### **Application No.: PL8889**

Description :	
Address :	
Record Type :	PLAT

<b>Document Filename</b>
01 MASTER PLAT APPLICATION.pdf
SWQMP REV.pdf
SUNSET RIDGE MASTER PRELIM PLAT REV2-3-26.pdf
UTILITY PLAN.pdf

**PRELIMINARY UTILITY PLAN**

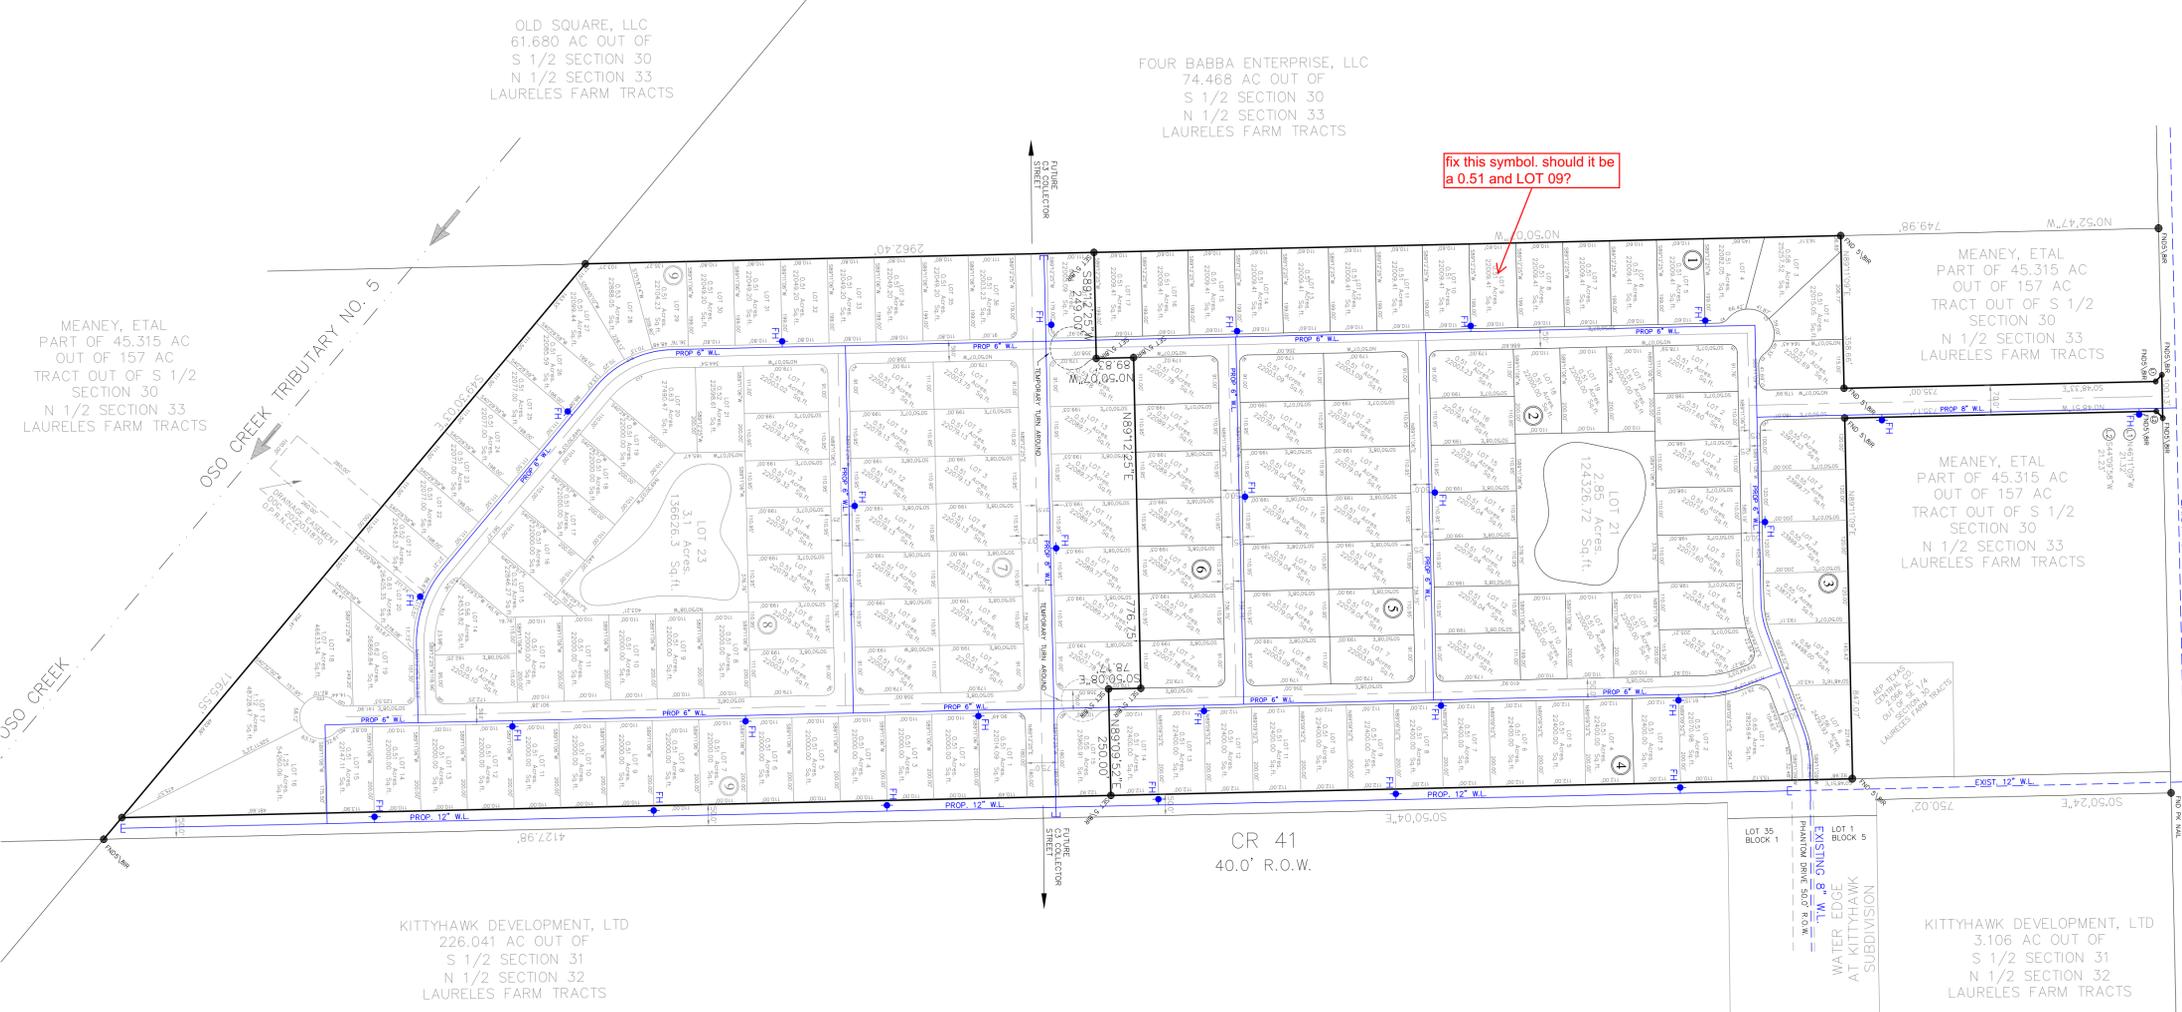
Comment ID	Page Reference	Annotation Type	Author : Department	Status	Review Comments	Applicant Response Comments
27	SWQMP	Callout	Alex Harmon : DS	Closed	Verify EOR is okay with concentration for pre and post development being the same. Generally, Tc decreases with paved route vs meandering open fields.	
6	U001	Note	Mina Trinidad : DS	Closed	<p>(Informational) Fire: (Comments 1-6)</p> <p>1. While currently existing as an OCL tract, annexation is forthcoming and this plat will need to meet UDC, Water a Fire Standards</p> <p>2. Water Distribution Standards: Fire flow for residential areas require 750 GPM with 20 psi residual</p> <p>3. 507.5.1 Exception 1: Group R-3 (one- or two-family dwellings): Fire hydrants to be located every 600 feet apart.</p> <p>4. 3310.1 Required access. Approved vehicle access for firefighting shall be provided to all construction or demolition sites. Vehicle access shall be provided to within 100 feet of temporary or permanent fire department connections. Vehicle access shall be provided by either temporary or permanent roads, capable of supporting vehicle loading under all weather conditions. Vehicle access shall be maintained until permanent fire apparatus access roads are available.</p> <p>5. D102.1 Access and loading. Facilities, buildings, or portions of buildings hereafter constructed shall be accessible to fire department apparatus by way of an approved fire apparatus access road with an asphalt, concrete or other approved driving surface capable of supporting the imposed load of fire apparatus weighing at least 75,000 pounds.</p> <p>6. 503.1.1 (amendment) Buildings and facilities: During construction, when combustibles are brought on to the site in such quantities as deemed hazardous by the fire official, access roads and a suitable temporary supply of water acceptable the fire department shall be provided and maintained.</p>

7	U001	Note	Mina Trinidad : DS	Closed	<p>Fire: (Comments 7-11)</p> <p>7. Note: An accessible road and a suitable water supply is required before going vertical with any structure.</p> <p>8. 503.2.1 Dimensions. Fire apparatus access roads shall have an unobstructed width of not less than 20 feet, exclusive of shoulders and an unobstructed vertical clearance of not less than 13 feet 6 inches.</p> <p>9. D103.1 Access road width with a hydrant. Where a fire hydrant is located on a fire apparatus access</p>

Comment ID	Page Reference	Annotation Type	Author : Department	Status	Review Comments	Applicant Response Comments
					<p>road, the minimum road width shall be 26 feet, exclusive of shoulders.</p> <p>10. Where Fire Apparatus Access is constructed to the minimum of 20 feet, no parking is allowed within the fire apparatus lane.</p> <p>Where a fire hydrant is located on the street, the minimum unobstructed clearance shall be 26 feet. In this instance, no parking is allowed on one side of the street. The minimum UDC residential street width is 28 ft. curb to curb. Any parking along the street that reduces the width to less than 20 ft. is prohibited and the Fire Code Official and will require painting "NO PARKING-FIRE LANE" along one side of the street.</p> <p>11. Note: Calculated Turning Radii for Fire Apparatus:            Inside Turn: 20 ft. 3 in.            Curb to curb: 36 ft. 8 in.            Wall to wall: 44 ft. 8 in.</p>

8	U001	Note	Mina Trinidad : DS	Closed	<p>Fire: (Comment 12)</p> <p>12. The street listed currently as "Temporary Turn-Around" labeled as a C-3 Collector and should be built as such.</p>	
9	U001	Note	Mina Trinidad : DS	Closed	<p>(Informational) Fire: (Comments 13 &amp; 14)</p> <p>13. 503.4 Obstruction of fire apparatus access roads. Fire apparatus access roads shall not be obstructed in any manner, including the parking of vehicles. The minimum widths and clearances established in sections D103 shall always be maintained.</p> <p>14. 503.3 Marking: Where required by the fire code official, approved signs, or other approved notices the include the words NO PARKING-FIRE LANE shall be provided for fire apparatus access roads to identify such roads to prohibit the obstruction thereof. The designation of a fire lane can be marked with conspicuous signs which have the words:" Fire Lane-No Parking" at 50-foot intervals. In lieu of signs, fire lanes may be marked along curbing with the wording, "Fire Lane-No Parking" at 15-foot intervals.</p>

10	U001	Note	Mina Trinidad : DS	Closed	<p>Fire: (Comment 15-18)</p> <p>15. D107.1 One- or two-family dwelling residential developments. Developments of one- or two-family dwellings where the number of dwelling units exceeds 50 shall be provided with two separate and approved fire apparatus access roads.</p>

Comment ID	Page Reference	Annotation Type	Author : Department	Status	Review Comments	Applicant Response Comments
					<p>16. D107.2 Remoteness. Where two fire apparatus access roads are required, they shall be placed a distance apart equal to not less than one-half of the length of the maximum overall diagonal dimension of the property or area to be served, measured in a straight line between accesses. Unless otherwise approved by the Fire Marshal.</p> <p>17. In accordance with the above requirements: C.R. 41 shall be developed to meet the requirements of a secondary entrance. This was discussed at a recent EA meeting. If the Developer wishes to install a gated entrance, there is nothing to stop the Kitty-Hawk subdivision from doing the same thing. Therefore CR 41 should be developed as an secondary entrance.</p> <p>18. D103.5 Fire apparatus access road gates. Gates securing the fire apparatus access roads shall comply with all the following criteria: Single gate width shall not be less than 20 feet. 12 feet gate width is required for a divided roadway (no center medium). Electric gates shall be equipped with a means of opening the gate by fire department personnel for emergency access. Emergency opening devices shall be approved by the fire code official. Note: The use of a Knox Gate Switch is currently required by the Fire Official. Methods of locking shall be submitted for approval by the fire code official. Note: The Knox Padlock is currently required by the Fire Official. Electric gate operators, where provided, shall be listed in accordance with UL 325. Gates intended for automatic operation shall be designed, constructed, and installed to comply with the requirements of ASTM F 2200.</p>

11	U001	Note	Mina Trinidad : DS	Closed	<p>Fire: (Comments 19 &amp; 20)</p> <p>19. 503.2.5 Dead ends. Dead-end fire apparatus access roads more than 150 feet in length shall be provided with an approved area for turning around fire apparatus.</p> <p>20. Table D103.4 Requirements for Dead-end fire apparatus access roads. Turnaround provisions shall be provided with a 96-foot diameter cul-de-sac.</p>	
28	U001	Callout	Alex Harmon : DS	Closed	fix this symbol. should it be a 0.51 and LOT 09?	
29	U001	Note	Alex Harmon : DS	Closed	Include estimated water usage on utility plan to ensure the proposed development is in compliance with the Comprehensive Plan, implementation plan and applicable Utility Master Plan and the availability and capacity of public improvements needed to support the development. (UDC 3.7)

Comment ID	Page Reference	Annotation Type	Author : Department	Status	Review Comments	Applicant Response Comments
30	U001	Note	Alex Harmon : DS	Closed	Approval of the plat does not approve the layout of public utilities, including but not limited to water, wastewater, stormwater and roadways. These items are only approved via Public Improvement Plans, which are required at time of final plat	
19	P001	Note	Caleb Wong : STREET	Closed	PW STR: Just to confirm, will the streets be private? This was discussed in the EAM but we want to ensure if they are going to be private or not.	
20	P001	Note	Caleb Wong : STREET	Closed	PW STR: Informational - Please refer to City of Corpus Christi Standards and Specifications for proposing roadwork, curb and gutter, sidewalk, utilities, etc and have the standards included in the plan set and the specifications referenced. Wherever available, please include a table of contents for which standards and specifications were used.
